Access Compliance Report

Public Rights-of-Way

(Curb Ramps)

Intersection ID: 5704	Main Street: W_W_T_HARRIS_BV	Cross Street: N_TRYON_ST	Location: N
ADA ID: 4FAC906F98D1	Ramp Type: Perp	Initial Pass/Fail: Pass	Overall Compliance: No
Severity Score: 5.25			
Codes/Mitigation Info/Possible Solution		Field Measurements/Component Compliance

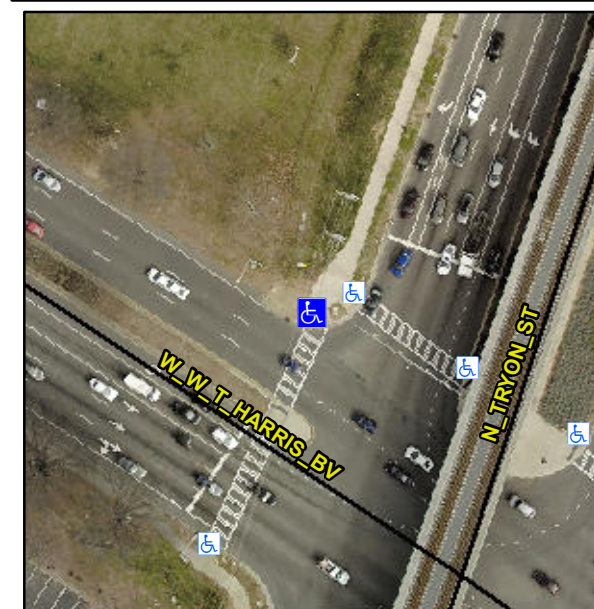
**Not Found, R304.5.3, R304.2.2-Perp,
R304.3.2-Para, R304.2.3, R305.1.4,
R305.2**

Compliance	Description	Data	Compliance	Description	Data
N/A	Ramp Length (in)	48.0	Yes	Ramp Slope (%)	6.3
Yes	Ramp Width (in)	48.0	No	Ramp XSlope (%)	3.8
N/A	Flare Type LT	Sloped	N/A	Flare Type RT	N/A
N/A	Flare Slope LT (%)	5.3	No	Flare Slope RT (%)	13.4
N/A	Flare Traversable LT?	Yes	N/A	Flare Traversable RT?	Yes
Yes	Landing Length (in)	48.0	Yes	DWS Provided?	Yes
Yes	Landing Width (in)	48.0	Yes	DWS Contrast?	Yes
No	Landing Slope (%)	5.1	No	DWS Length (in)	23.5
No	Landing X Slope (%)	4.6	Yes	DWS Full Width?	Yes
N/A	Landing Curb? (Y/N)	No	No	DWS Offset (in)	3.5
N/A	Shared Landing?	Yes			
Yes	Gutter Ponding?	No	Yes	Gutter Slope (%)	3.7
Yes	Gutter Lip Ht (in)	0.0	No	Gutter X Slope (%)	3.2
N/A	Painted X Walk1?	No	N/A	Painted X Walk2?	N/A
	X Walk 1 Direction	To SW		X Walk 2 Direction	N/A
N/A	X Walk 1 Width (in)	N/A	N/A	X Walk 2 Width (in)	N/A
	X Walk 1 Slope (%)	2.2		X Walk 2 Slope (%)	N/A
	X Walk 1 X Slope (%)	3.0		X Walk 2 X Slope (%)	N/A

**Remove & Replace Entire Ramp.
Remove & Replace Gutter.**
